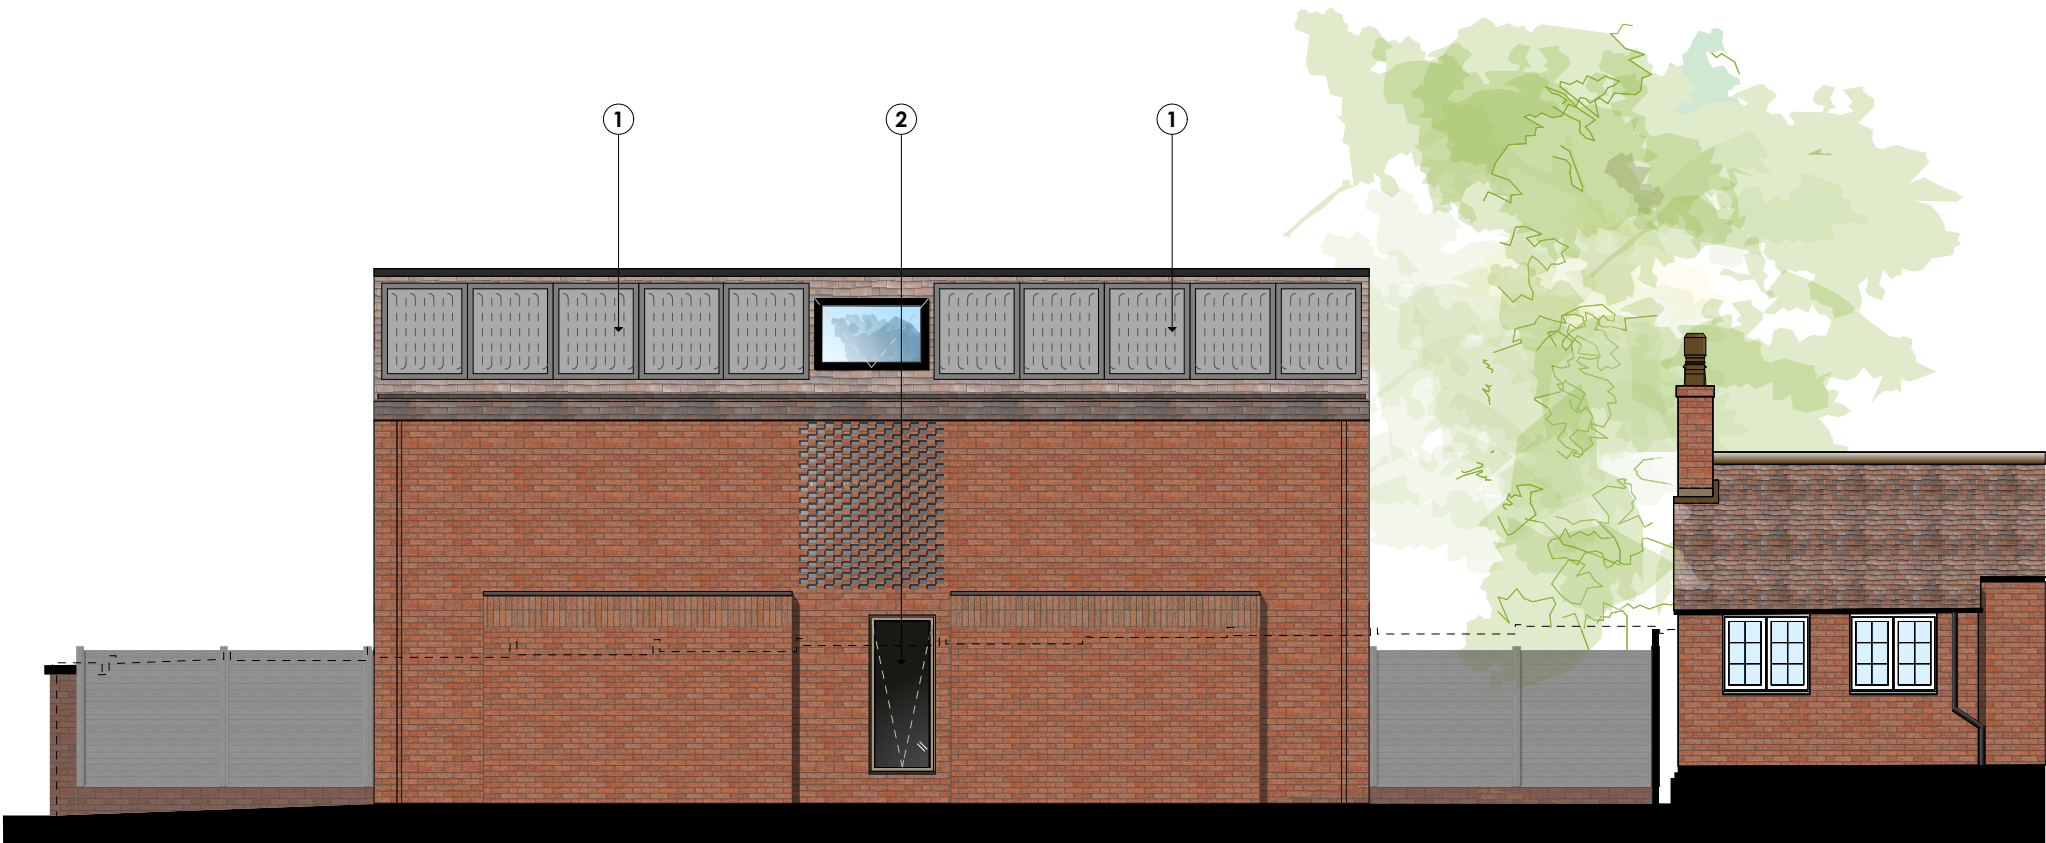
Changes:

(1) Approved bedroom skylights removed to accommodate 10x PV panels

(2) Hit & Miss brickwork screen replaced with single window at ground floor.

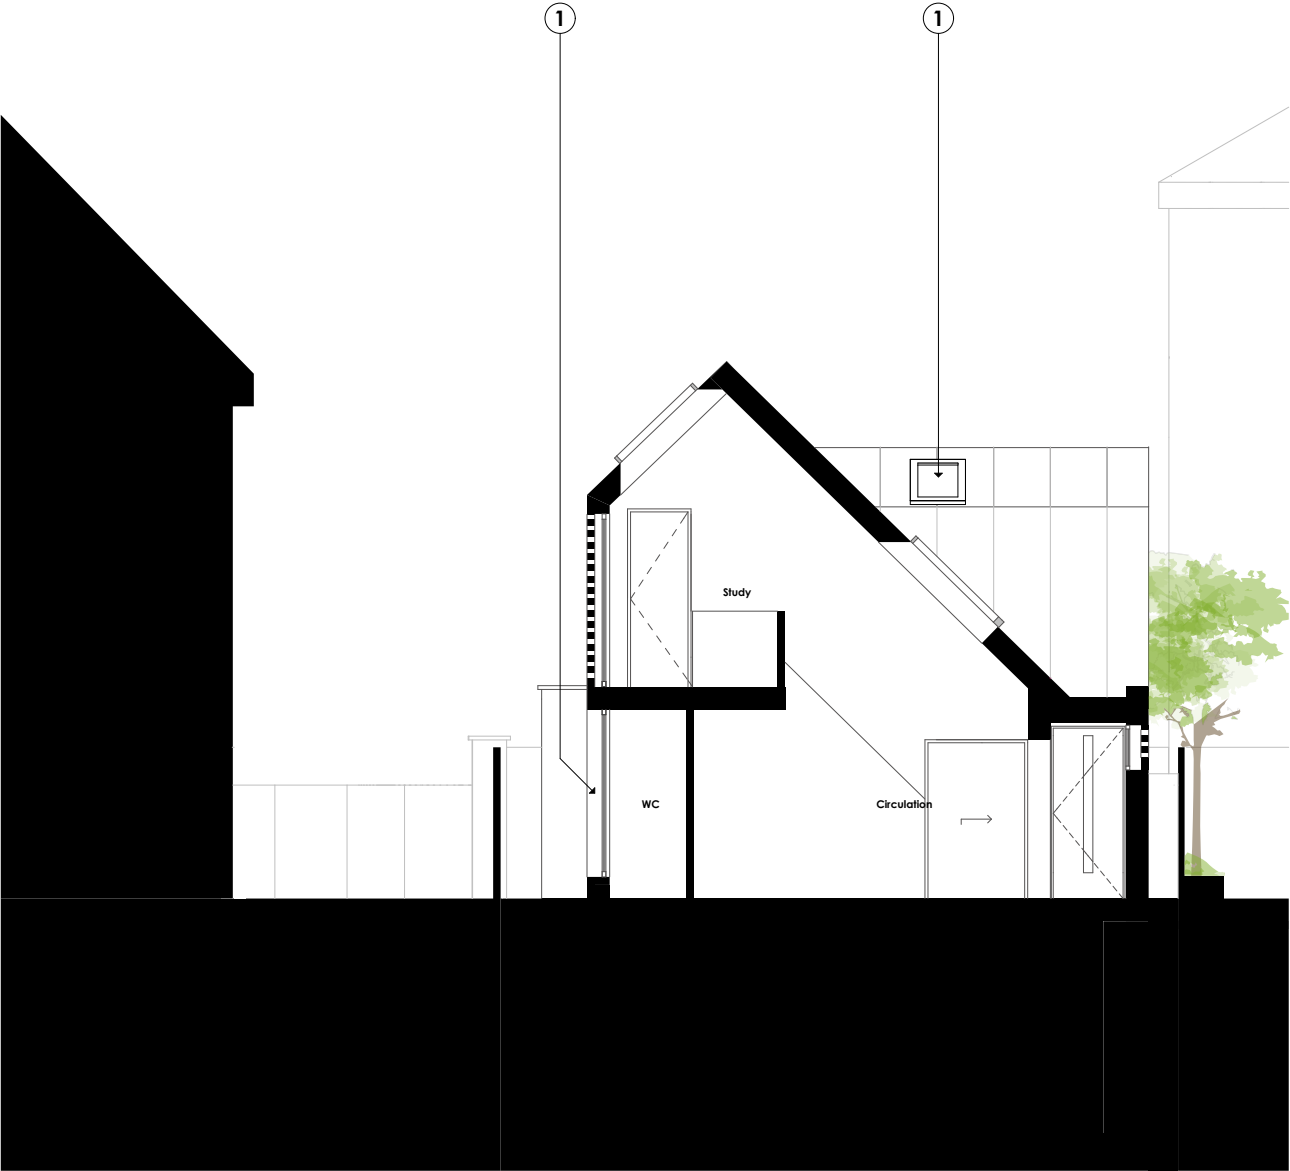
Changes:
(1) Covered walkway at ground floor enclosed forming enlarged kitchen dining through relocated utility at rear of property. High level glazing on north elevation.
(2) Approved bedroom skylights removed to accommodate 10x PV panels

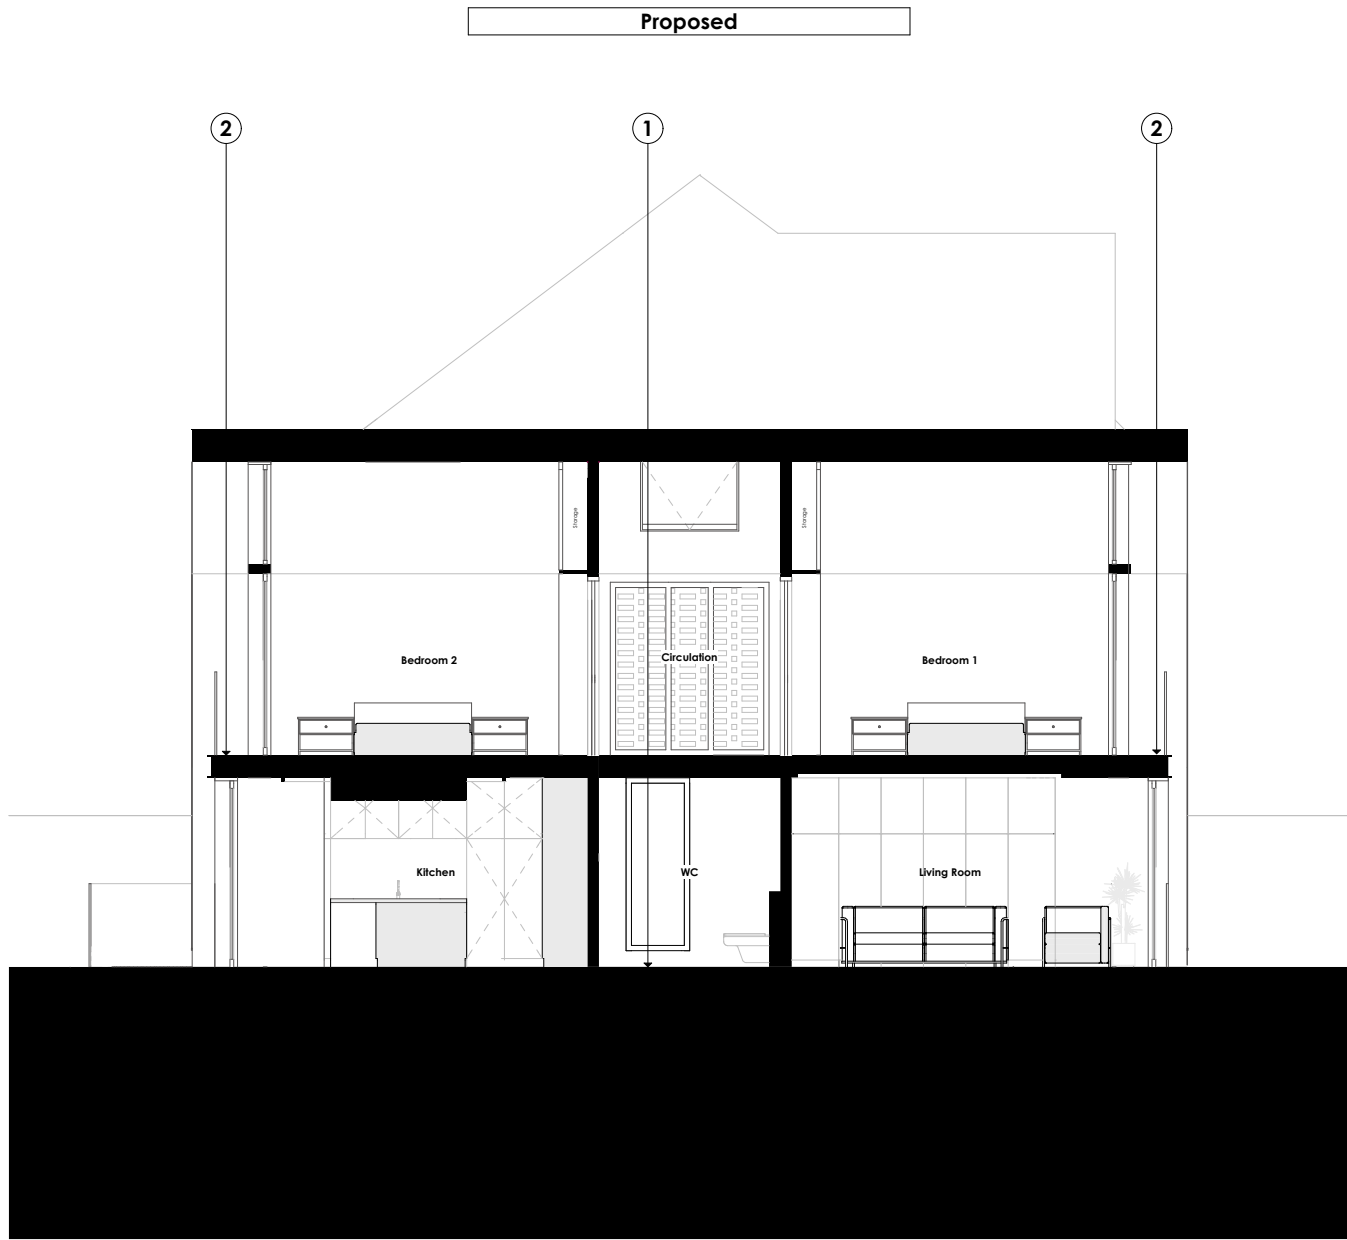
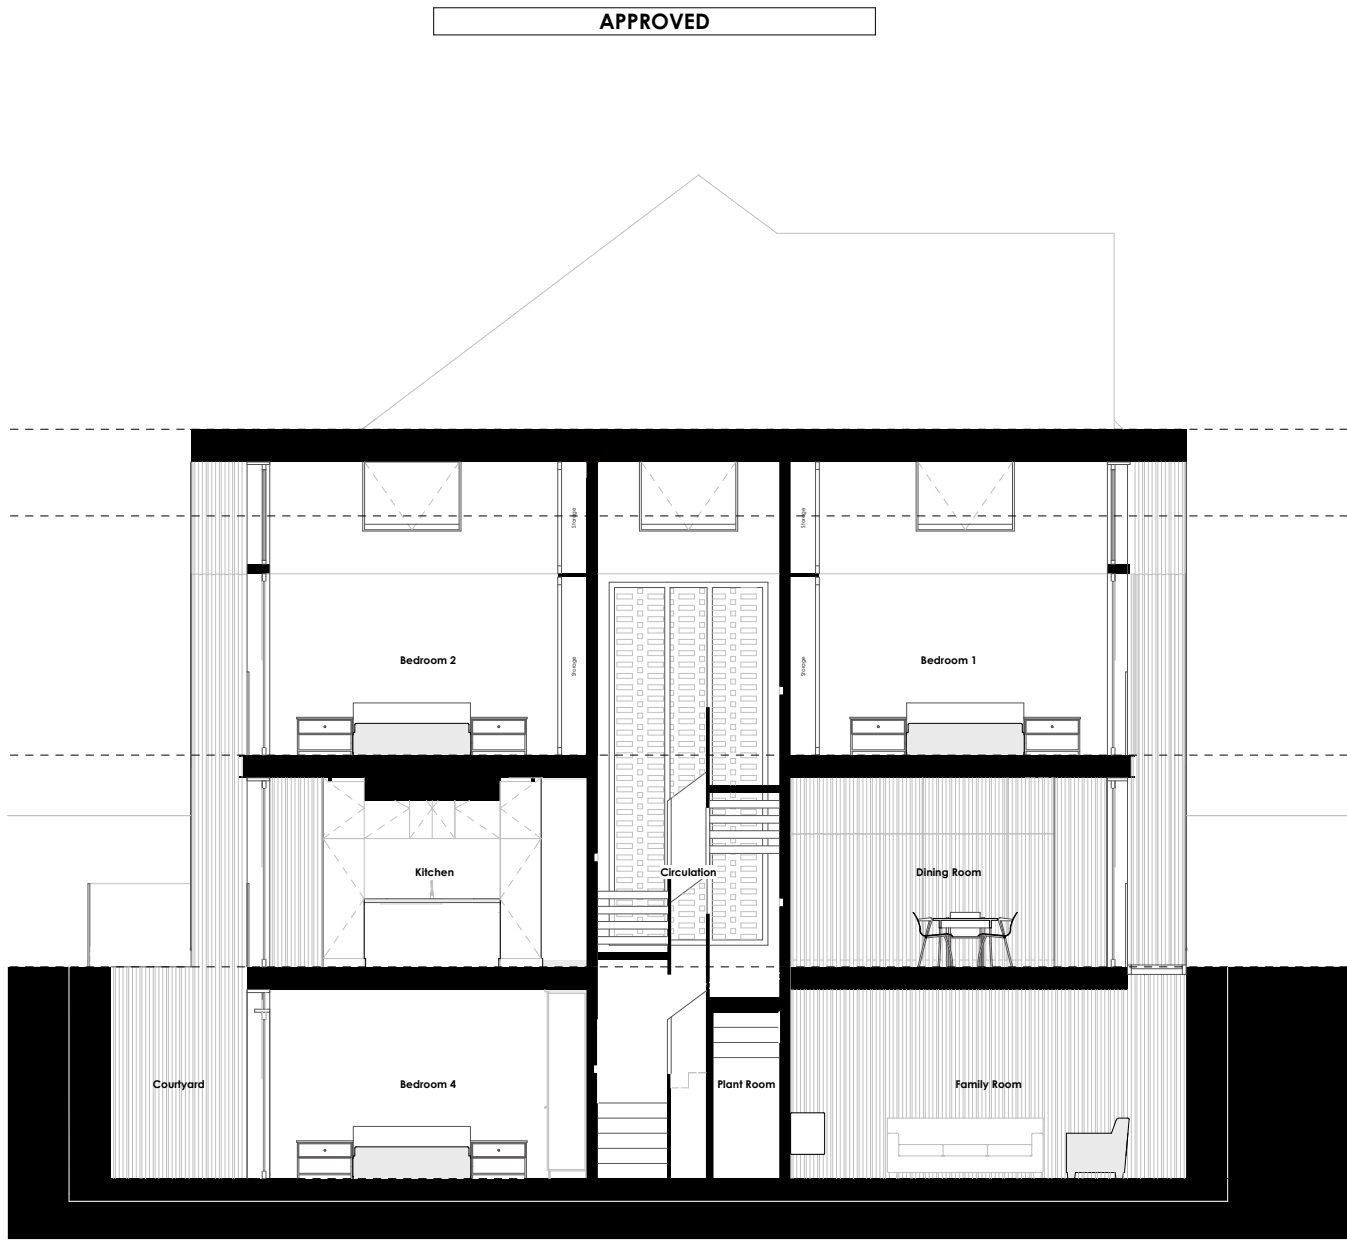
Changes:
(1) New skylight(s) installed on inner face of dormer.
(2) Hit & Miss brickwork screen replaced with single window at ground floor.
